re: Geotechnical Review - McKinnon's Creek Alterations
Proposed residential Development
Summerside West - Tenth Line Road - Ottawa

to:David Schaeffer Engineering Limited - **Ms. Jennifer Ailey** - jailey@dsel.ca
to:David Schaeffer Engineering Limited - **Mr. Steve Pichette** - spichette@dsel.ca
to:Mattamy Homes - **Ms. Jillian Normand** - Jillian.Normand@mattamycorp.com
date:November 26, 2018
file:PG4049-MEMO.10 Revision 2

Northern Office and Laboratory
63 Gibson Street
North Bay - Ontario - P1B 8Z4
Tel: (705) 472-5331 Fax: (705) 472-2334

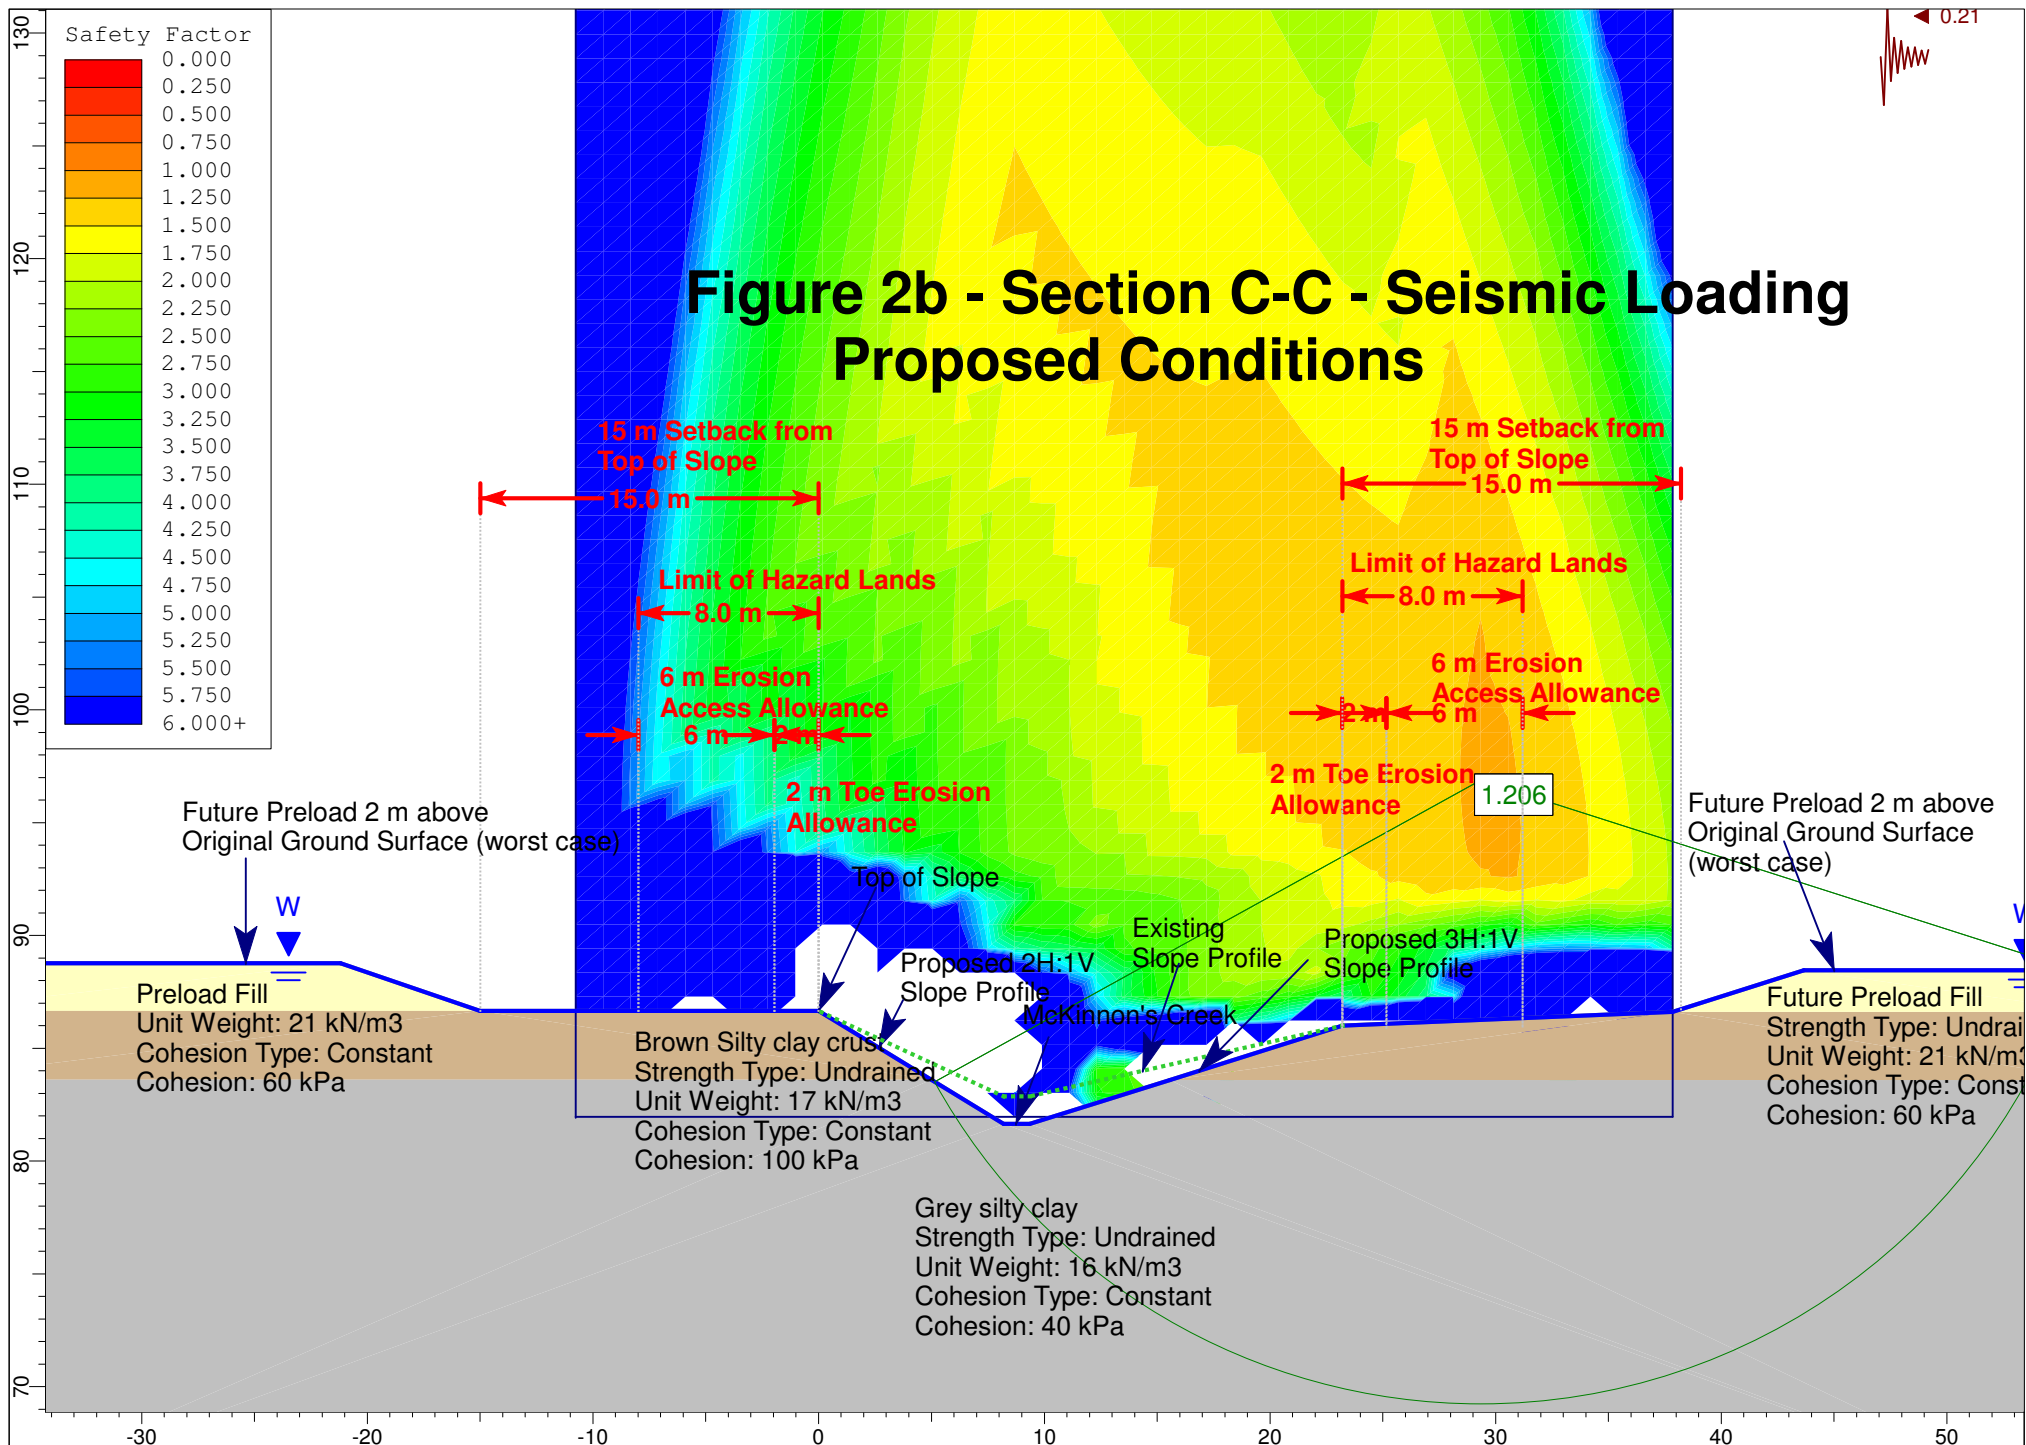
The results of our analysis are presented in Figures 1a, 1b, 2a and 2b attached. Figures 1a and 1b present the results of our global slope stability analysis under static conditions for each side slope of the channel and Figures 2a and 2b present the analysis when considering the seismic loading. Based on our analysis results, Section C-C is considered stable with a global slope stability factor of safety of greater than 1.5 under static conditions and greater than 1.1 under seismic loading. Therefore, a slope stability setback is not required for the limit of hazard lands setback.

SECTION C-C

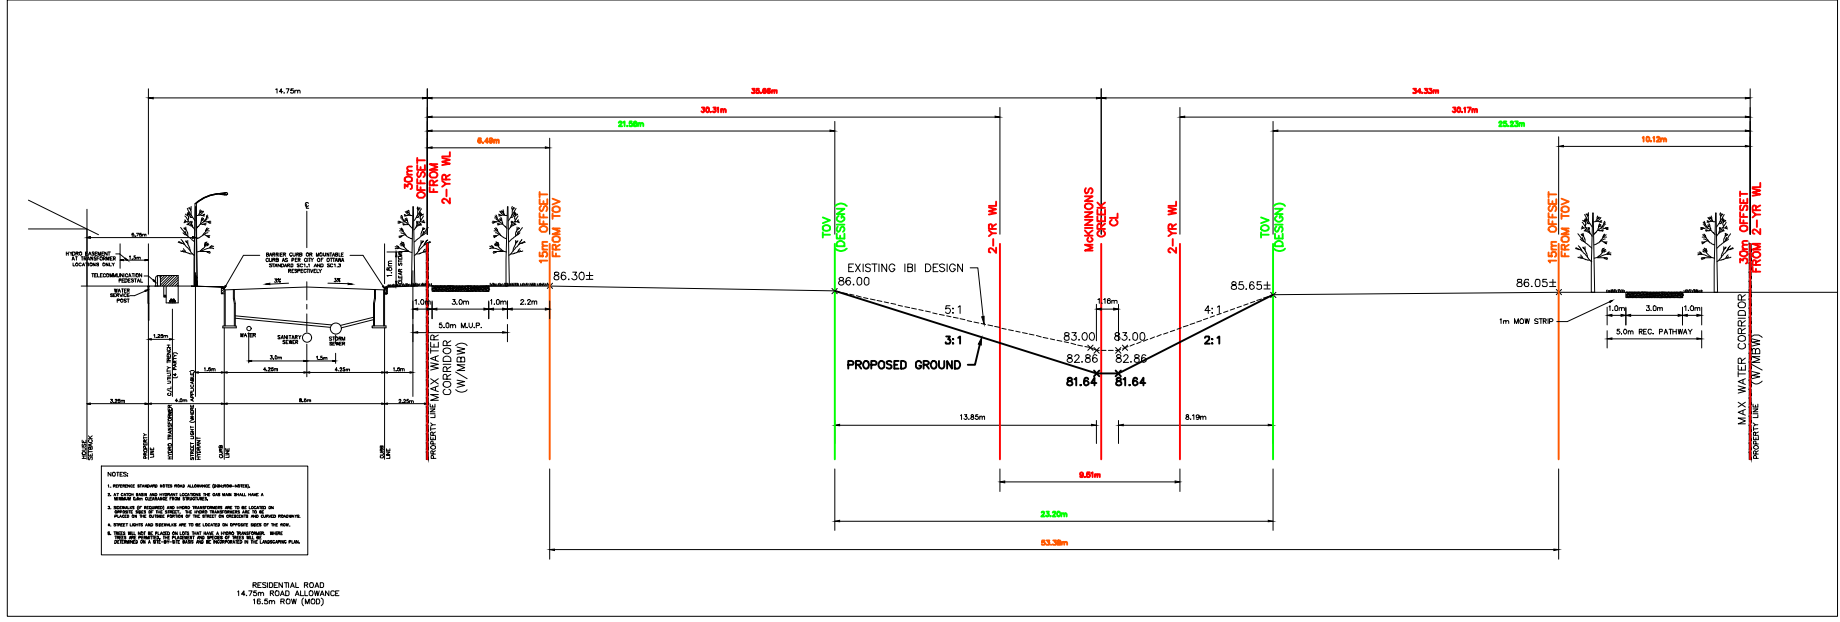
The slope sections presented in the design drawing were reviewed by Paterson. Based on our review, Section C-C was noted to include a 2H:1V slope profile along the east side of the channel and a 3H:1V slope profile along the west side. The remainder of the proposed slope profiles were observed to be greater than 2H:1V. Therefore, Section C-C was analyzed to determine the global slope stability factor of safety as the worst case scenario for the proposed alterations. **The slope stability analysis also considered a 2 m high preload above original ground surface. It should be noted that the assumed 2 m preload fill height is well above the design roadway and pathway grading adjacent to McKinnon's Creek along the west side and is approximately 0.5 m above anticipated lot grading for the lots adjacent to McKinnon's Creek along the east side of the alignment. It should also be noted that no preloading will be completed beyond the geotechnical limit of hazard lands. Also, it should be noted that a settlement surcharge program is not required for the lots, pathways or roadways adjacent to the subject alignment of McKinnon's Creek.**
